## 2020-07 BAR Decision for 418 East Jefferson Street

BAR 20-07-08

418 East Jefferson Street

**CITY OF CHARLOTTESVILLE  
BOARD OF ARCHITECTURAL REVIEW  
STAFF REPORT**  
July 21, 2020

NORTH (E JEFFERSON ST) - SHEET 05

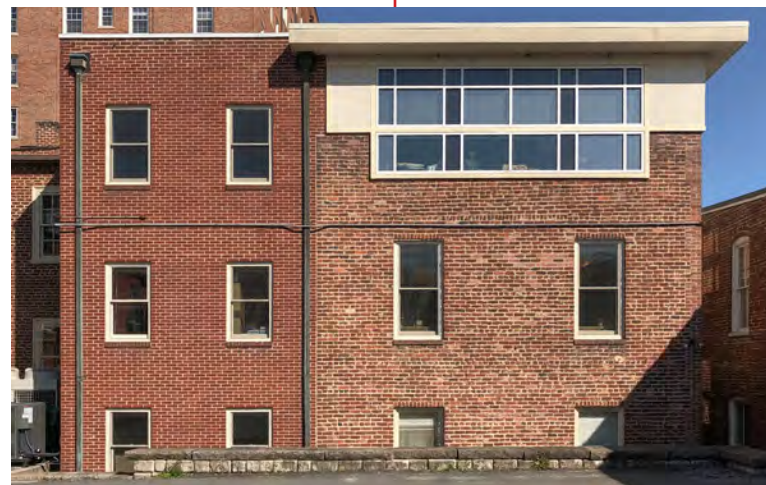
I just went over and tried to stick a knife in the areas you have highlighted on the first floor NE window. That material is still solid. The horizontal rail of the sash in the photo is rotten and the knife went right in.

On the N. elevation, there are a couple of spots on the 2<sup>nd</sup> floor at the base of the vertical trim that look questionable. These are hard to get to right now (interior storm window, window fixed, need a ladder), these will have to be examined more carefully when the job gets underway (Alexander Nicholson is the contractor).

In most areas, it is the sashes that are either rotten, warped, dried-out or falling apart. The existing frames (including the boxes for sash weights), sills and exterior trim are mostly in OK shape. Again, if material is rotten, or split/broken, it will be replaced.

01. A-R ELEVATION

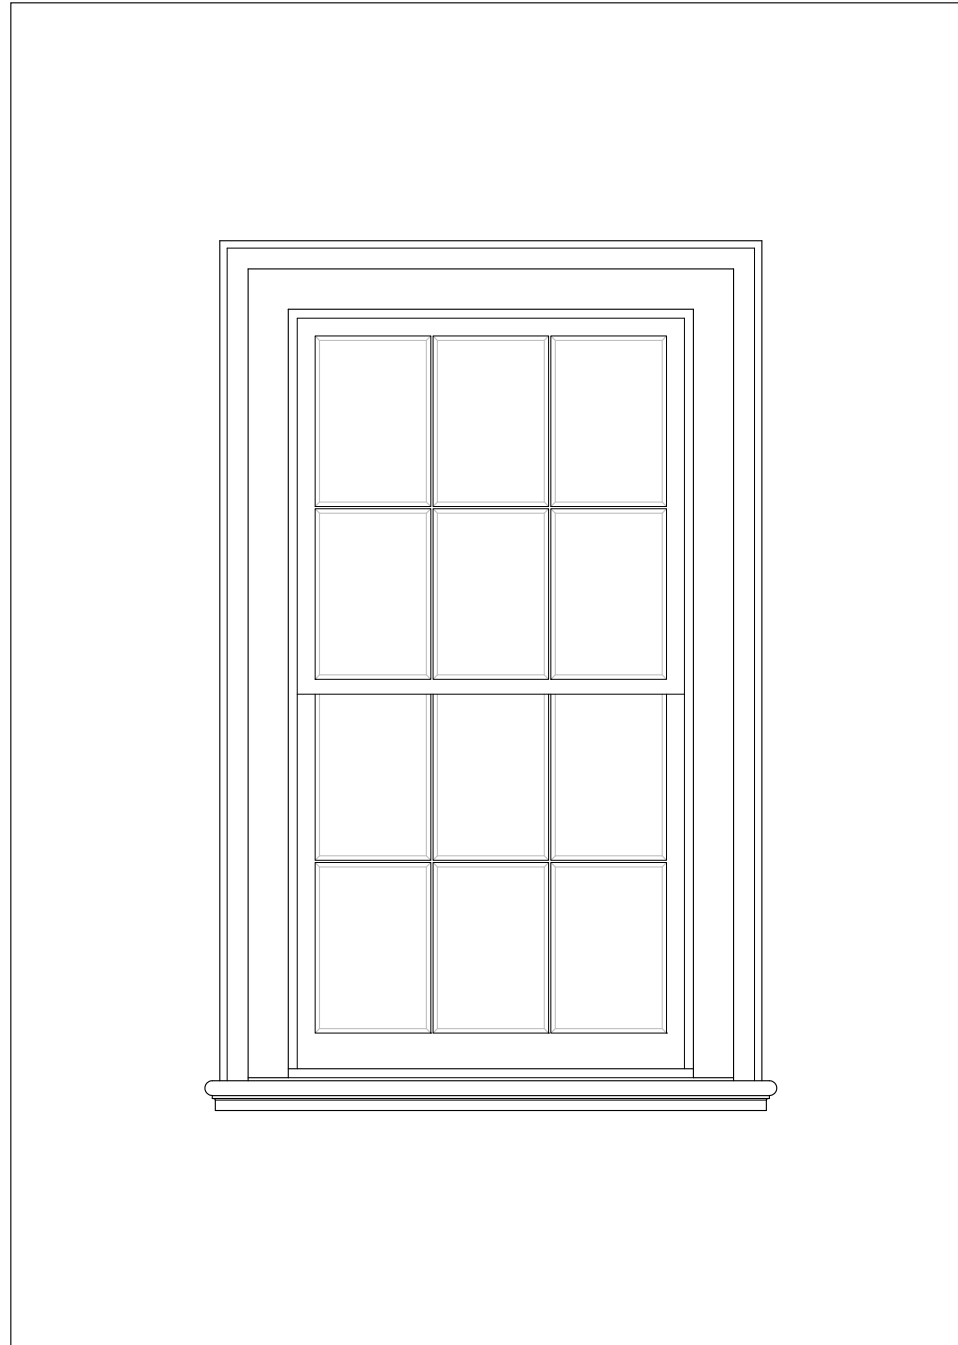
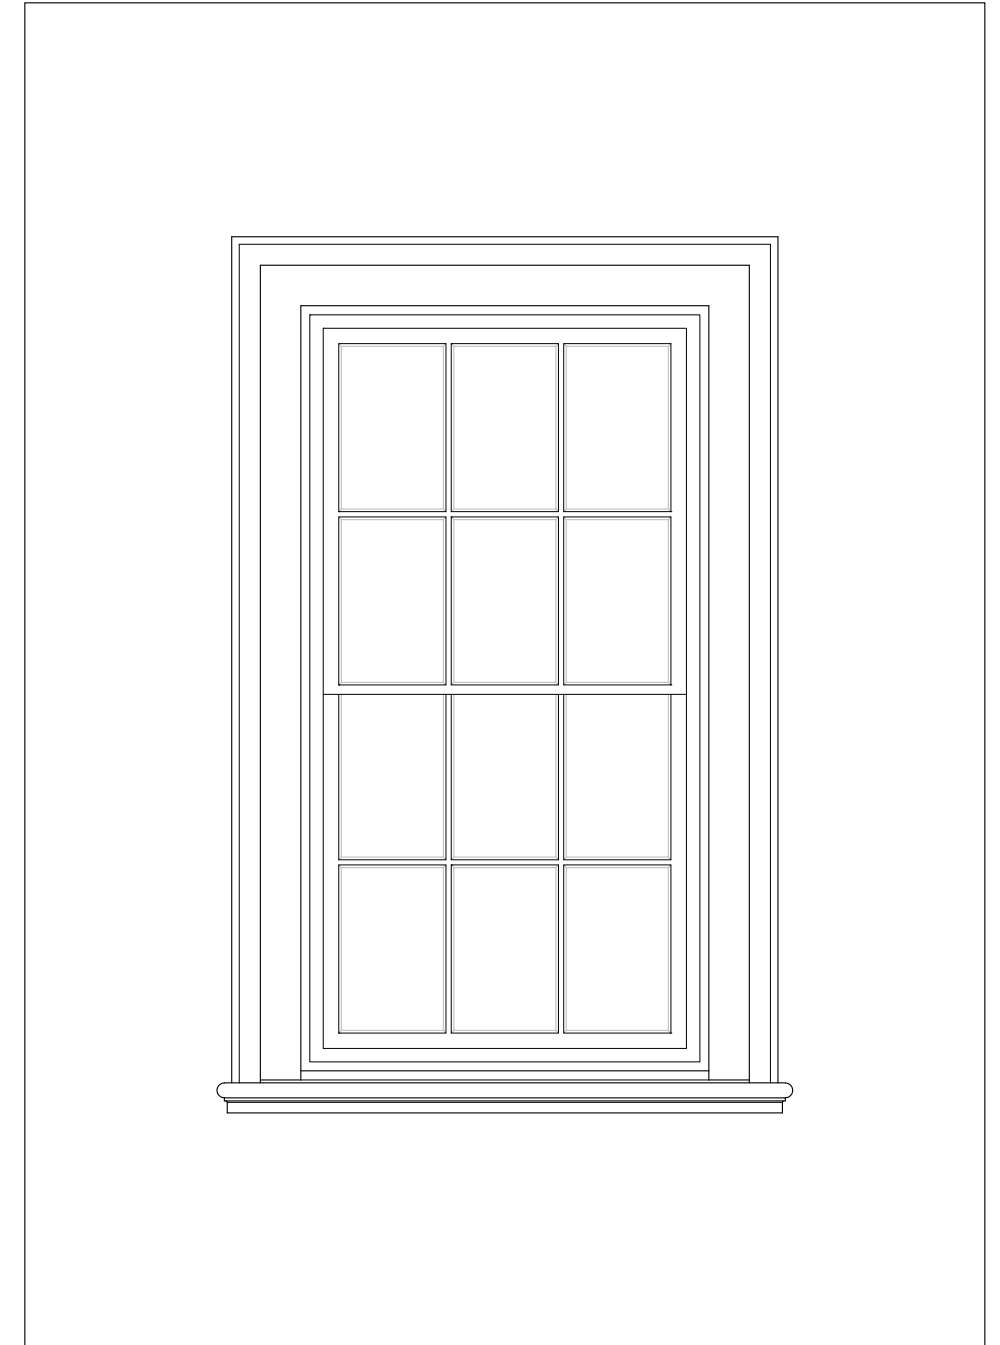
WINDOW "A" - EITHER (SEE NARRATIVE)  
 A-R EXISTING TO BE REHABILITATED OR REPLACED - SEE DETAIL 01, SHEET 07.  
 A-M NEW MARVIN ULTIMATE DOUBLE HUNG INSERT G-2 - SEE DETAIL 02, SHEET 07.  
 REPAIR & REPAINT EXISTING TRIM

BAR Member James Zehmer moves: Having considered the standards set forth within the City Code, including City Design Guidelines for Rehabilitation, I move to find that the proposed Option 2 for window repairs and replacements (as specified in the application) satisfies the BAR's criteria and is compatible with this property and other properties in the North Downtown ADC District, and that the BAR approves the application as submitted.

02. PROPOSED WINDOW "B" & BRICKWORK

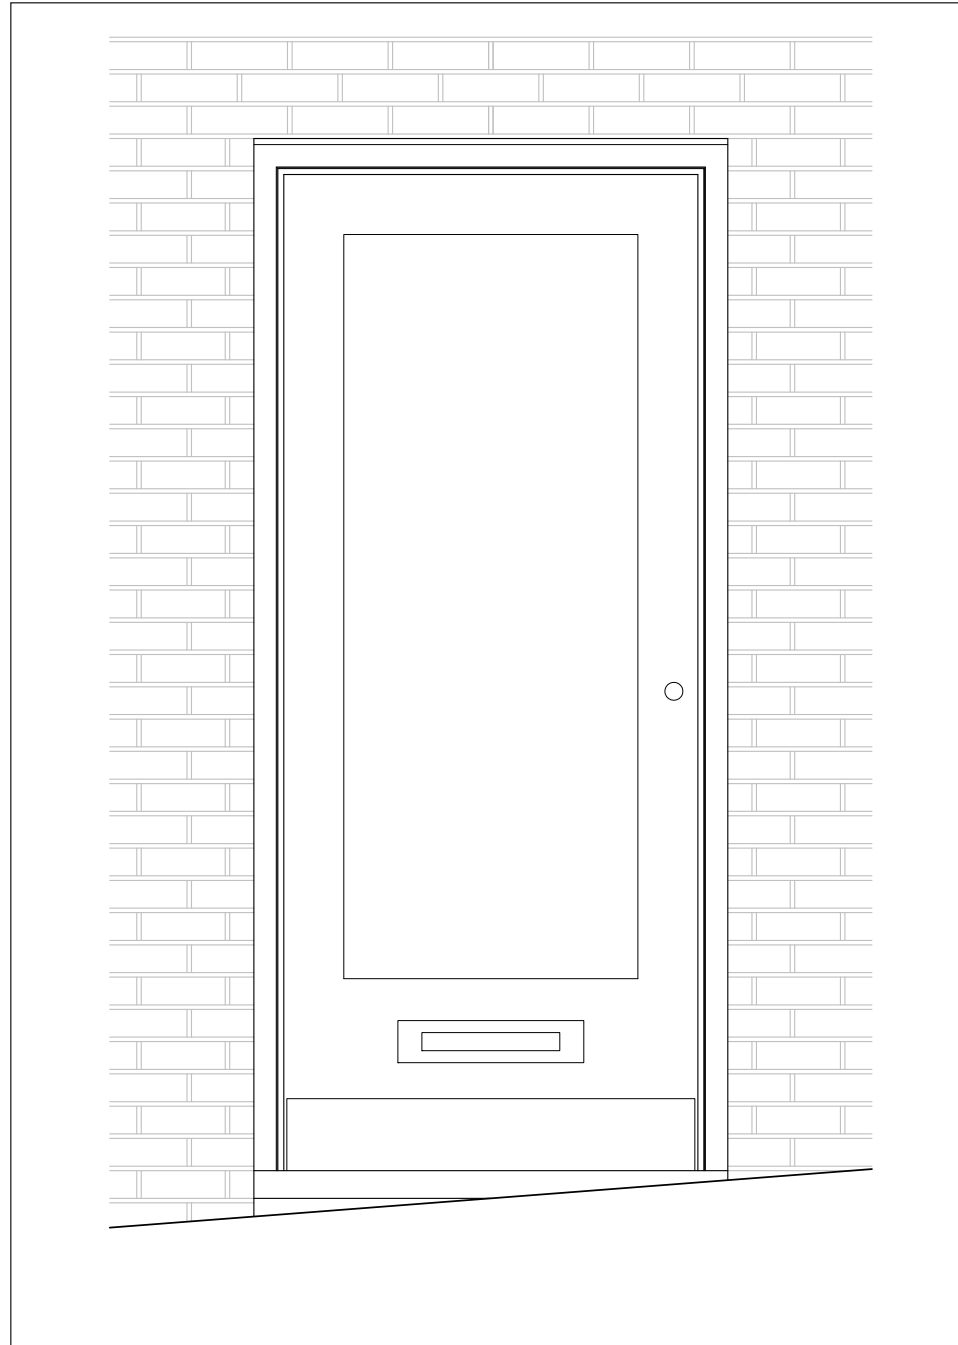
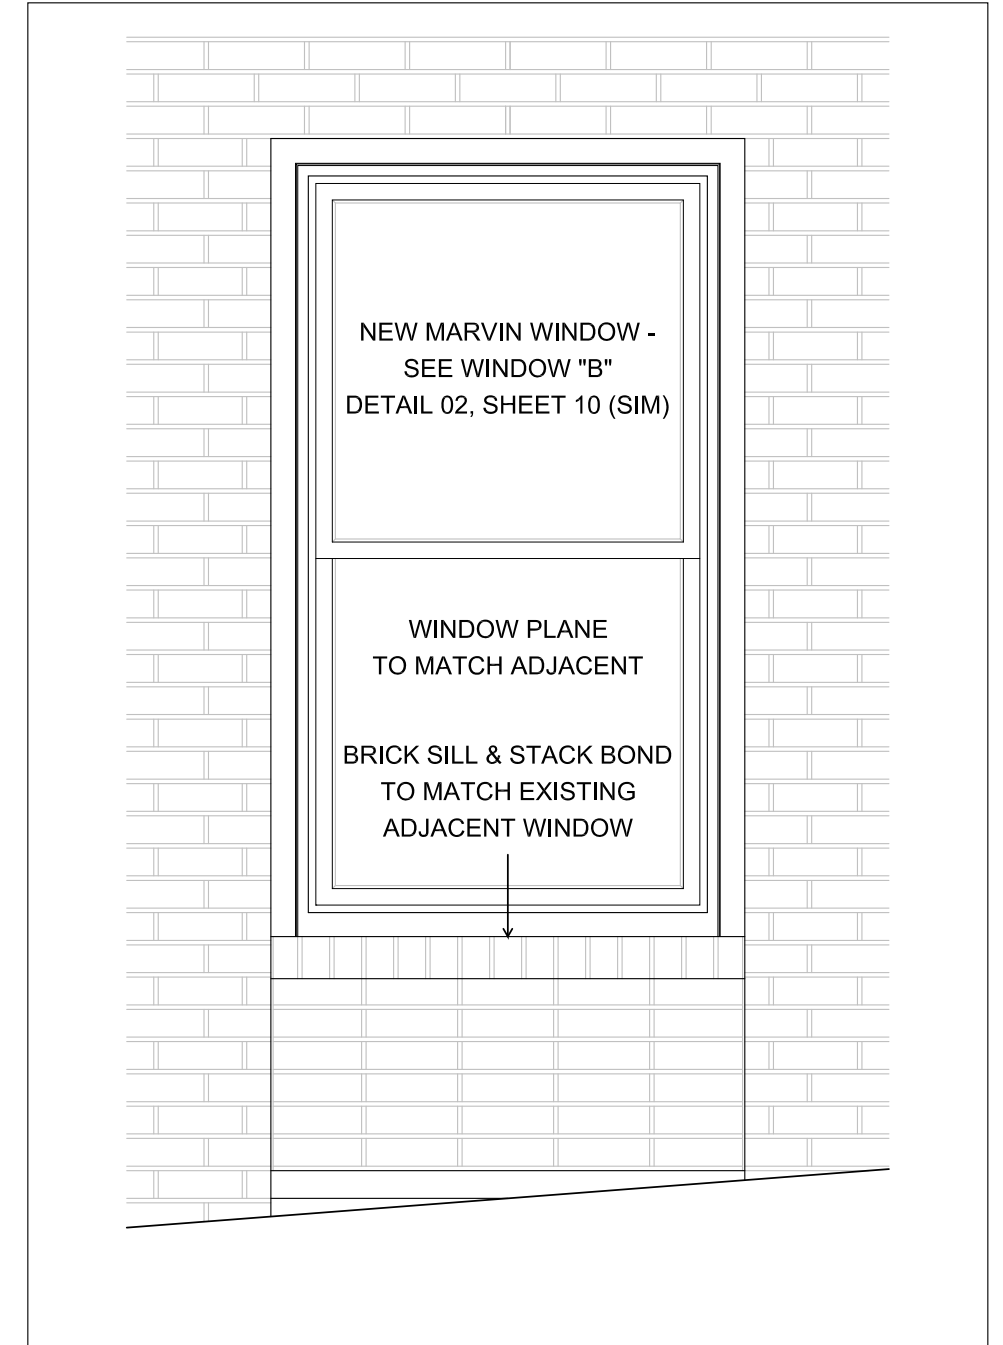
REMOVE EXISTING DOOR AND FRAME, FILL IN MASONRY AROUND NEW WINDOW TO MATCH EXISTING OPENING HEIGHT AND WIDTH.
